TECHNICAL NOTE 4 (TN04)

**Stage 1 Road Safety Audit
Designers Response**

**Albrighton South
(Application 24/02108/OUT)**

December 2024

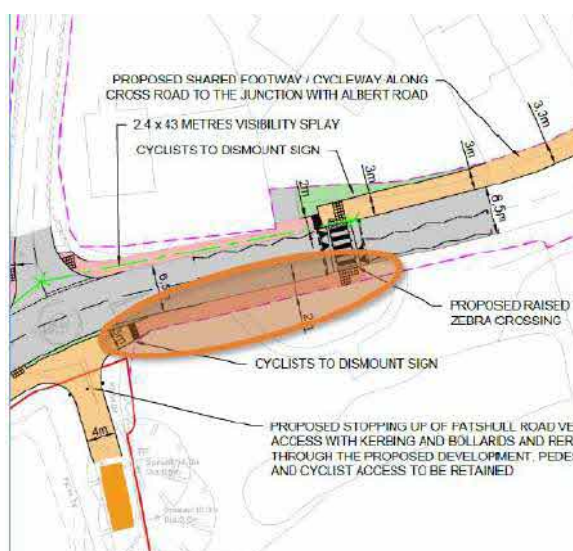
3.2 PROBLEM A1

Location: Cross Road – adjacent to the junction with Albert Road.

Summary: Lack of onward cycle route risks cycle to pedestrian collisions.

The proposed shared footway/cycleway ends close to the mini-roundabout junction of Cross Road and Albert Road. There is no obvious onward route for cyclists and no way for cyclists to rejoin the carriageway here. This may lead to them continuing their journey on the footway which is too narrow to be safely shared beyond this point, risking cycle to pedestrian collisions.

It is recommended that a safe way for cyclists to join and exit the facility here are provided.

Recommendation Accepted

As shown on **Drawing Number SH5034-4PD-005 Revision B (RSA Appendix B)**, a cycle egress point has been provided approximately 50m to the south-west of the Cross Road / Albert Road Roundabout to provide an appropriate transition back on to the existing carriageway for cyclists travelling north east on the proposed shared footway/cycleway. Appropriate signage will be provided as part of the detailed design of the scheme to confirm that cyclists should exit the shared path in this location. Signage will also be provided to confirm that 'access' to the shared facility for cyclists travelling south-west bound is not permitted.

Cyclists travelling south-west on Cross Road towards the site will be able to access the proposed shared footway/cycleway on the southern side of the carriageway approximately 260m to the south west of the Cross Road / Albert Road Roundabout at the proposed parallel crossing.

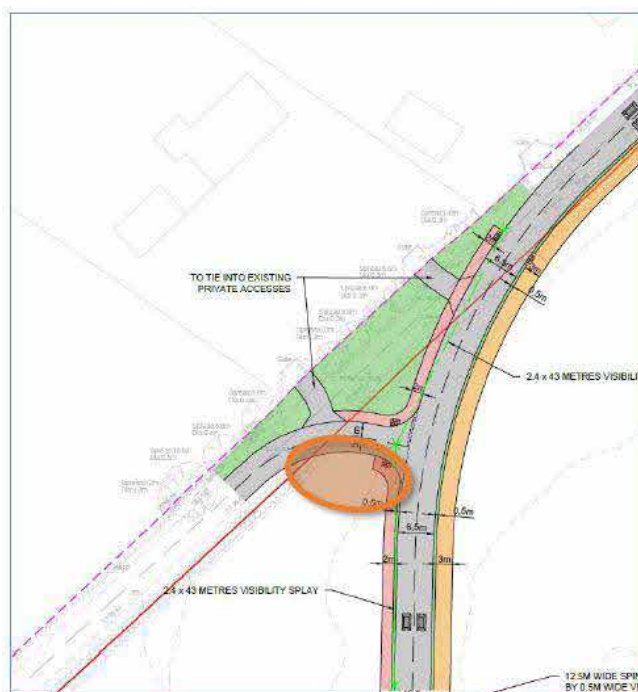
3.3 PROBLEM A2

Location: Cross Road – southern footway between Patshull Road and the shared footway/cycleway on the northern side of Cross Road.

Summary: Cyclist dismount violations likely to lead to cycle to pedestrian collisions.

There is a gap in the cycle provision between Patshull Road and the zebra crossing linking to the onward route on the northern side of Cross Road. It is unlikely, given the length of the gap, that cyclists will dismount here, resulting in a risk of cycle to pedestrian collisions within the “gap” and on the crossing.

It is recommended that the link between the crossing and onward route is widened to a point where shared use can be safely accommodated and that the crossing is upgraded to a parallel crossing.

Recommendation Accepted

As shown on **Drawing Number SH5034-4PD-004 Revision B (RSA Appendix B)**, the section of footway referenced in the audit comment has been widened to provide a continuous section of shared footway/cycleway between the previously proposed provision to the west and the proposed crossing point.

The new section of shared footway/cycleway measures between 2.7m and 3.0m in width. Whilst it is acknowledged that 3m is the recommended minimum width for a shared footway/cycleway (DfT Guidance LTN 1/20), the available width is limited by adopted highway and land ownership constraints in this location. Notwithstanding this, the provision of a short section of reduced width shared footway/cycleway, marginally below the recommended width should, on balance, be considered acceptable in this location as it allows

The proposed widening of this section to a shared footway/cycleway is achieved via that narrowing of the carriageway to 5.5m along this short stretch. This still facilitates the two - way movements of larger vehicles and is the minimum width that can be provided to facilitate the proposed footway/cycleway widening.

As shown on **Drawing Number SH5034-4PD-004 Revision B (RSA Appendix B)**, in line with the RSA recommendation, the previously proposed zebra crossing has been upgraded to provide a parallel pedestrian/cyclist crossing which ensures that there is a continuous off-road cycleway link between the proposed Albrighton South site and the Cross Road / Albert Road Roundabout junction to the north-east.

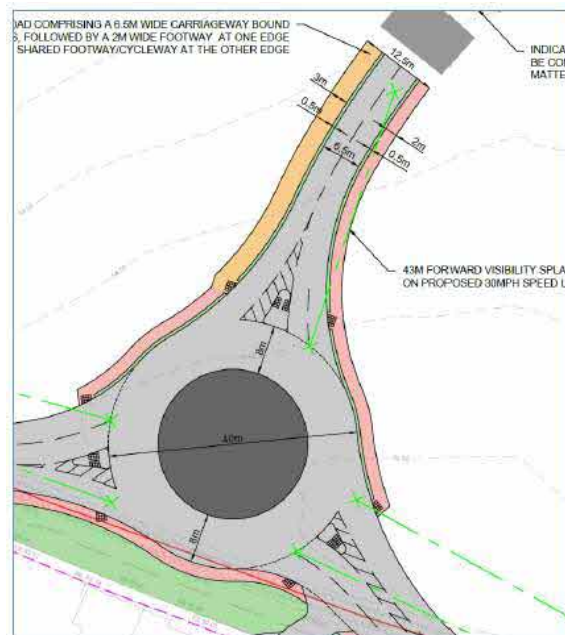
3.6 PROBLEM A6

Location: Cross Road – approaches to the realigned carriageway.

Summary: See-through to old alignment risks loss of control incidents.

Whilst it is appreciated that the traffic calming will reduce speeds for the majority of vehicles, there is a risk that drivers or riders approaching the realigned junction on Cross Road will be confused by being able to see the historic (current) alignment, resulting in westbound vehicles crossing the centre line or eastbound vehicles approaching the junction with excessive speed, risking loss of control incidents.

It is recommended that additional measures to highlight the presence of the junction and new alignment are provided as part of the detailed design.

Recommendation Accepted

In line with the RSA recommendation, additional measures will be provided to highlight the presence of the junction and new road alignment as part of the detailed design process.

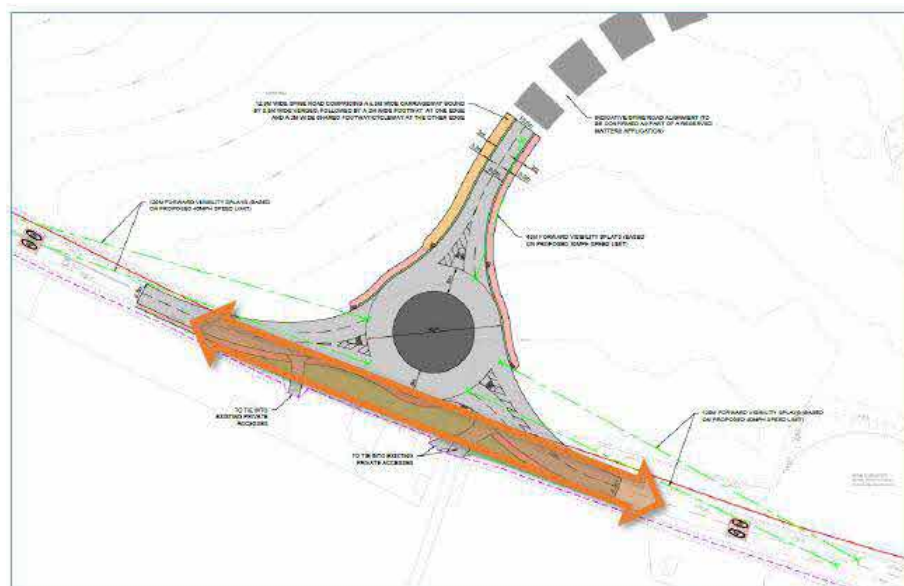
Location: A464 Holyhead Road – proposed roundabout junction.

The drawing provided show visibility splays based on the proposed 40mph speed limit. It was observed that Holyhead Road is currently subject to the national speed limit and, whilst it is appreciated that the proposals include gateway features and rumble strips / 40mph roundels along Holyhead Road, some high vehicle speeds were observed during the site visit and it is unclear whether the proposed measures will have the desired reduction in speeds. Should insufficient visibility be provided there is a risk of junction overshoots or shunt type collisions.

It is recommended that unobstructed visibility splays commensurate with likely vehicle speeds, as opposed to the speed limit, are provided.

Recommendation Noted

As set out in the TA submitted in support of the application, ATC surveys were undertaken on the A464 Holyhead Road to establish the speed of vehicles in the vicinity of the proposed site access junction locations. The ATC (ATC 1 in the TA) located in the approximate location of the proposed roundabout junction recorded the following speeds:

In terms of the existing speed limit on the road, whilst this is currently national speed limit (60mph) along the A464 Holyhead Road site frontage, the DfT Setting Local Speed Limits (March 2024) document states at paragraph 131, Table 2 that a 60mph speed limit is only recommended for *'most high quality strategic A and B roads with few bends, junctions or accesses'*. In terms of a 50mph speed limit Table 2 states to a 50mph limit *'Should be considered for lower quality A and B roads that may have a relatively high number of bends, junctions or accesses. Can also be considered where mean speeds are below 50mph, so lower limit does not interfere with traffic flow'*. Based on the above DfT guidance, it is clear that, whilst the current speed limit on the A464 Holyhead Road along the frontage of the site is 60mph, in practice it could realistically be reduced to 50mph without the requirement for any additional traffic calming measures, given that the stretch of the A464 in question clearly meets the criteria set out for a 50mph road with a number of accesses and bends.

The proposals submitted for audit included reducing the speed limit to 40mph along the A464 over a distance of 1.6km to encompass the proposed site accesses. This 40mph speed limit would be enforced via the provision of the new access junctions as well as a suite of additional measures set out in **Drawing Number SH5034-4PD-011 Revision A (RSA Appendix B)**, including speed repeater signage, roundels on the road, gateway features, rumble strips, lining to reduce the visual width of the road and potential (subject to S278 requirements) lighting to reduce vehicle speeds. In addition to this, the provision of development on land to the north of the site access junctions will change the nature of the road, which is currently rural in nature. The speed reducing measures proposed all take reference from the information provided in the DfT Traffic Calming (1/07) guidance document, which provides the evidence basis which supports reducing speed limits and how effective measures can be.

It should be noted that the LHA reviewed the speed reducing measures and the proposals to reduce the speed limit to 40mph along the frontage of the A464 as part of their TA review response to the application. In the LHA response, it was confirmed that *"SC has reviewed (the speed reducing and speed limit reduction measures) and considers information acceptable subject to further detailed design and road safety audits"*. As such, it is clear that SC Highways are amenable to progressing the Traffic Regulation Order (TRO) required to reduce the speed of the road from 60mph to 40mph.

Based on the above information, and the fact that the LHA are broadly supportive of the proposals to reduce the speed limit on the A464 along the site frontage, it is not considered appropriate to provide visibility splays in line with recorded speeds as these will not be representative of vehicle speeds when the speed limit of the road is reduced and the speed reducing measures agreed as appropriate with the LHA have, together with the proposed site access, been implemented.

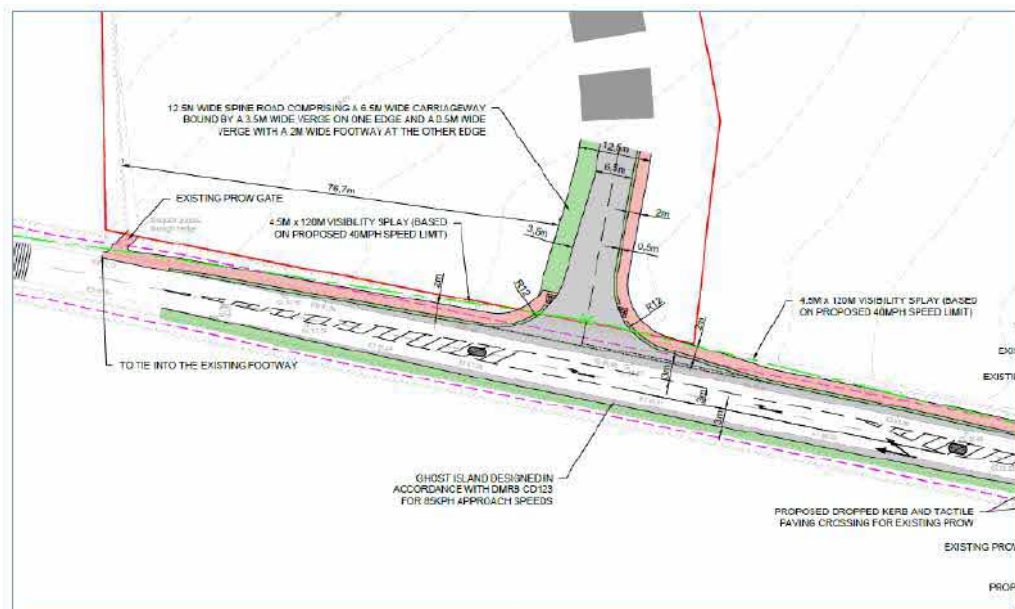
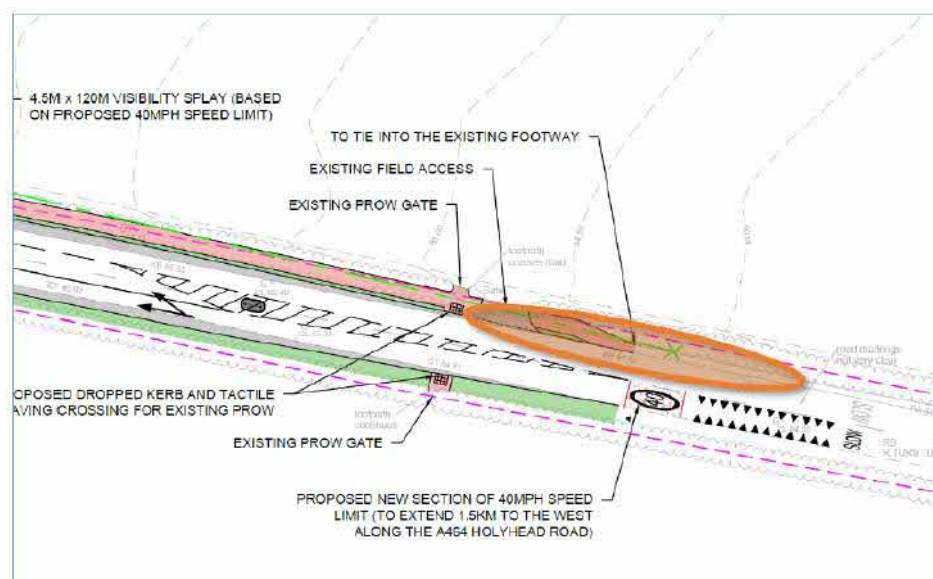
3.10 PROBLEM A9

Location: A464 Holyhead Road – proposed ghost right turn priority junction.

Summary: Lack of visibility risks junction pull-out type collisions.

The drawing provided show visibility splays based on the proposed 40mph speed limit. As mentioned above Holyhead Road is currently subject to the national speed limit and whilst it is appreciated that the proposals include gateway features and rumble strips / 40mph roundels along Holyhead Road, some high vehicle speeds were observed during the site visit and it is unclear whether, especially given the proximity of the junction to the start of the 40mph speed limit, the proposed measures will have the desired reduction in speeds. Should insufficient visibility be provided there is a risk of drivers exiting the junction into the path of vehicles on Holyhead Road resulting in side-impact or shunt type collisions.

It is recommended that unobstructed visibility splays commensurate with likely vehicle speeds, as opposed to the speed limit, are provided at the junction.

Recommendation Accepted

As set out in the TA submitted in support of the application, ATC surveys were undertaken on the A464 Holyhead Road to establish the speed of vehicles in the vicinity of the proposed site access junction locations. The ATC (ATC 3 in the TA) located in the approximate location of the ghost island right turn lane junction recorded the following speeds:

As shown above, vehicle speeds - in particular mean vehicle speeds - are significantly below the current posted 60mph limit.

In line with the Designers Response to 'Problem A7' it is considered that, given the speed reducing measures proposed and the in principle agreement from the LHA to the reduction in speed limits, it is considered that the provision of 120m visibility splays associated with the proposed 40mph speed limit are appropriate in this instance.

Notwithstanding this, the proposed speed limit change from 60mph to 40mph has been relocated to commence approximately 250m to the east of the ghost island right turn lane junction. This is approximately 100m further east than was shown on the site access junctions that were submitted for audit. The relocated speed limit location and package of speed reducing measures on approach to the junction are shown at **Drawing Number SH5034-4PD-011 Revision A (RSA Appendix B)**.

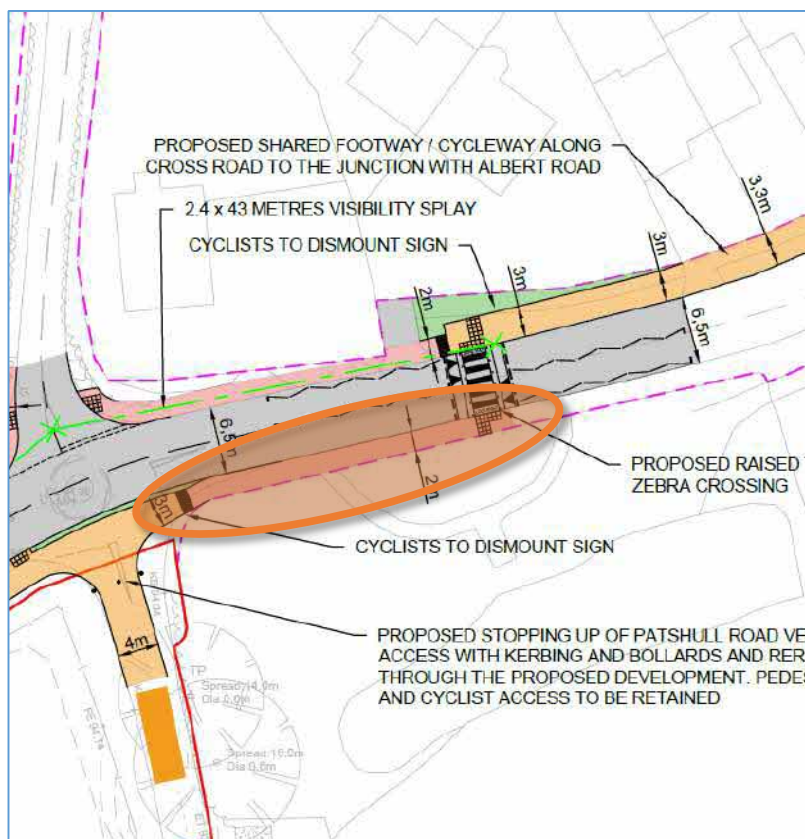
3.2. [Problem A1](#)

Location: Cross Road – adjacent to the junction with Albert Road.

Summary: Lack of onward cycle route risks cycle to pedestrian collisions.

The proposed shared footway/cycleway ends close to the mini-roundabout junction of Cross Road and Albert Road. There is no obvious onward route for cyclists and no way for cyclists to rejoin the carriageway here. This may lead to them continuing their journey on the footway which is too narrow to be safely shared beyond this point, risking cycle to pedestrian collisions.

It is recommended that a safe way for cyclists to join and exit the facility here are provided.

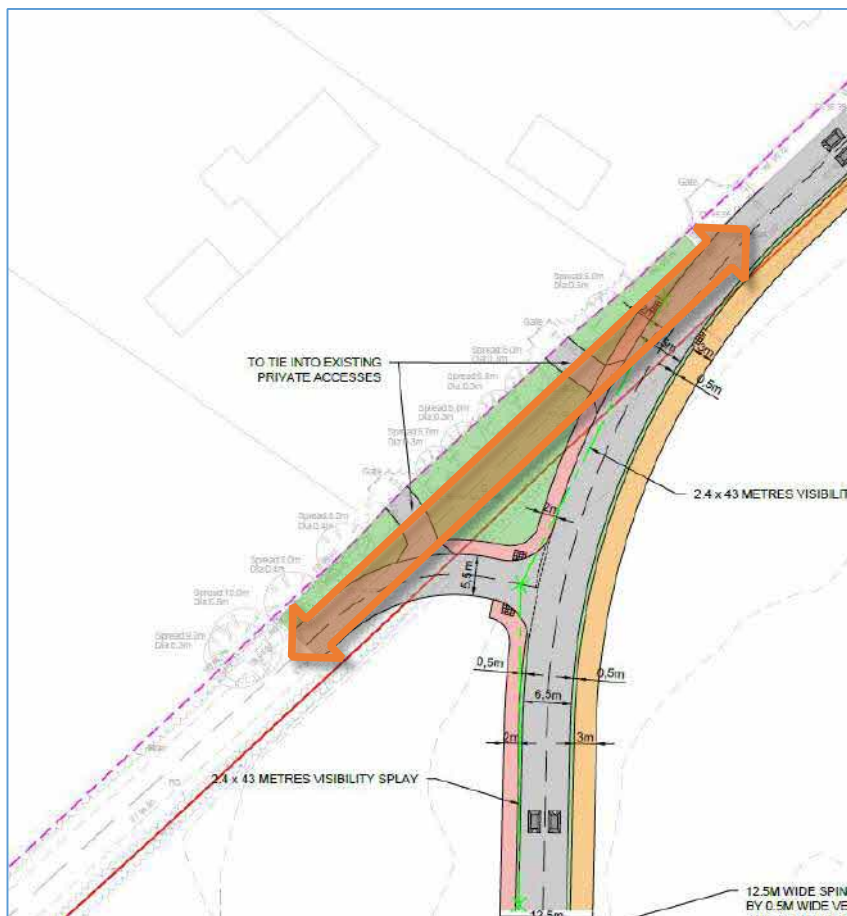
Summary: Lack of visibility risks vehicle to pedestrian collisions.

It is recommended that unobstructed visibility of vehicles approaching from the west is provided for pedestrians looking to cross south to north at the junction.

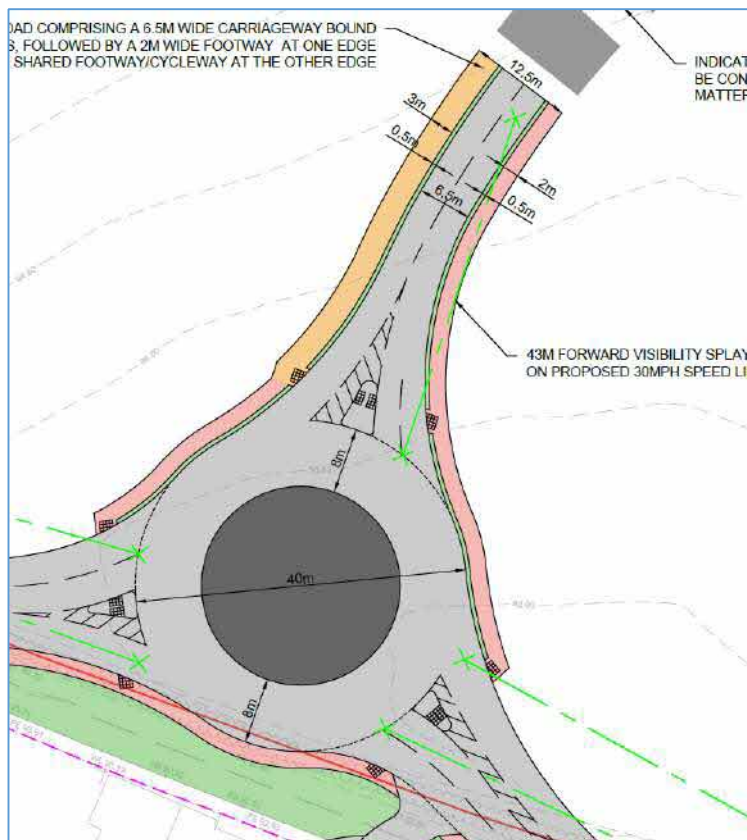
3.6. Problem A5

Location: Cross Road – approaches to the realigned carriageway.

Summary: See-through to old alignment risks loss of control incidents.

Whilst it is appreciated that the traffic calming will reduce speeds for the majority of vehicles, there is a risk that drivers or riders approaching the realigned junction on Cross Road will be confused by being able to see the historic (current) alignment, resulting in westbound vehicles crossing the centre line or eastbound vehicles approaching the junction with excessive speed, risking loss of control incidents.

It is recommended that additional measures to highlight the presence of the junction and new alignment are provided as part of the detailed design.

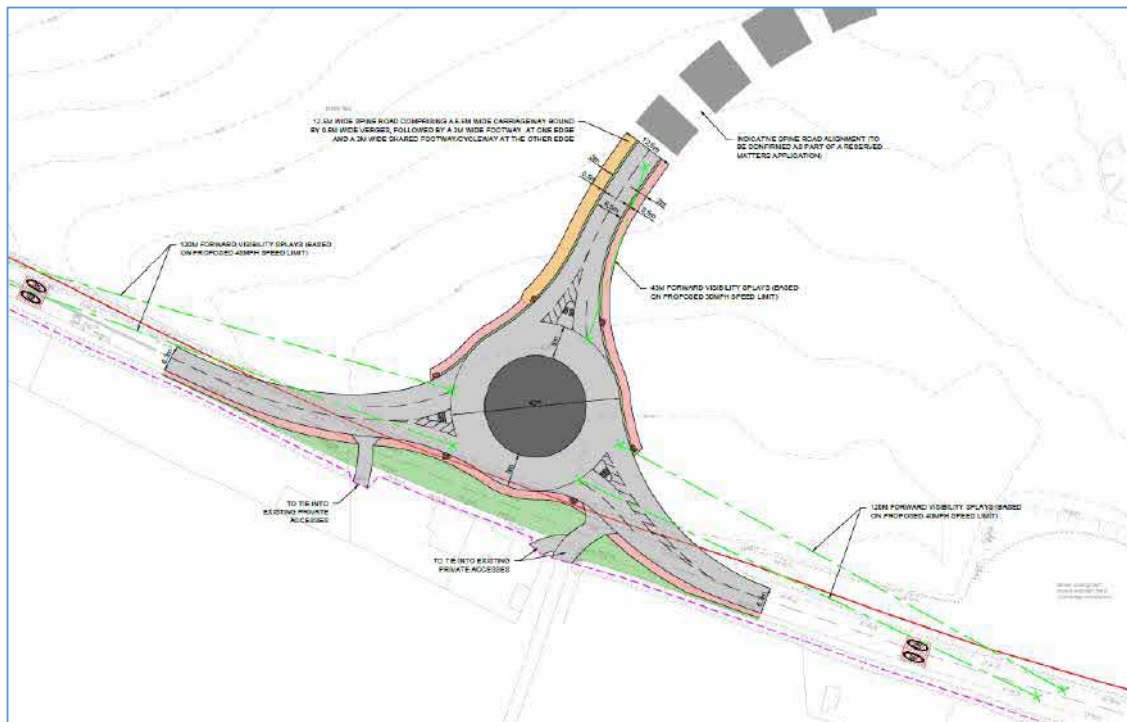
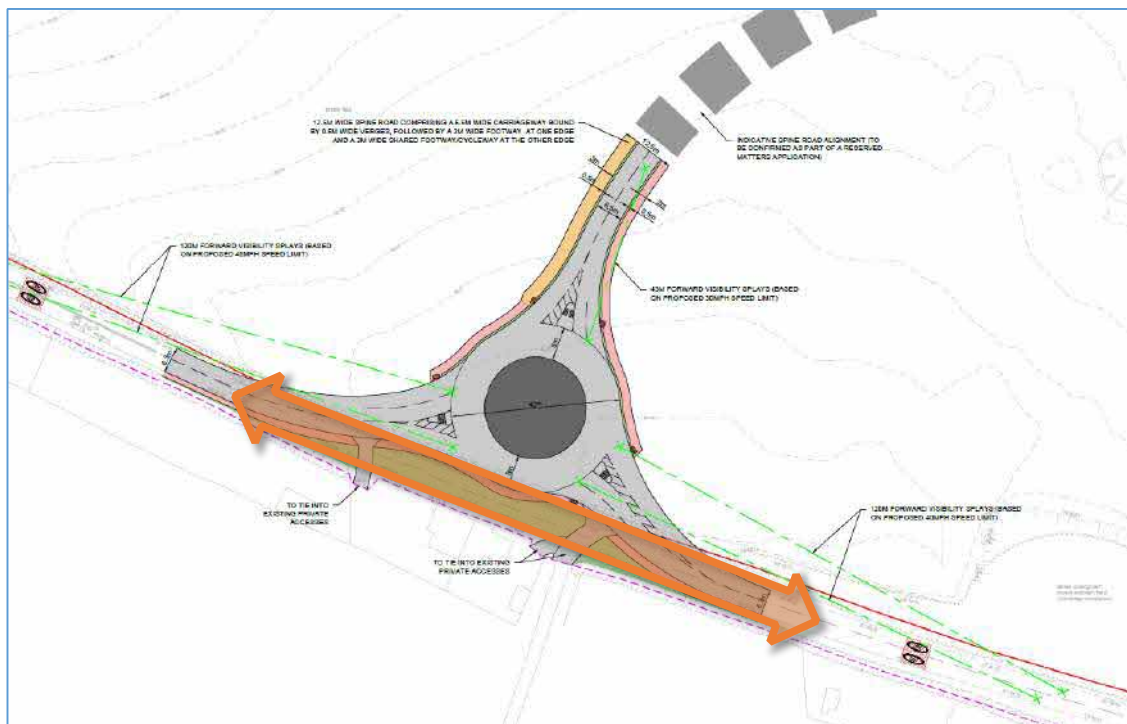
Summary: Lack of forward visibility risks inappropriate speed and junction overshoots / shunt type collisions.

The drawing provided show visibility splays based on the proposed 40mph speed limit. It was observed that Holyhead Road is currently subject to the national speed limit and whilst it is appreciated that the proposals include gateway features and rumble strips / 40mph roundels along Holyhead Road, some high vehicle speeds were observed during the site visit and it is unclear whether the proposed measures will have the desired reduction in speeds. Should insufficient visibility be provided there is a risk of junction overshoots or shunt type collisions.

It is recommended that unobstructed visibility splays commensurate with likely vehicle speeds, as opposed to the speed limit, are provided.
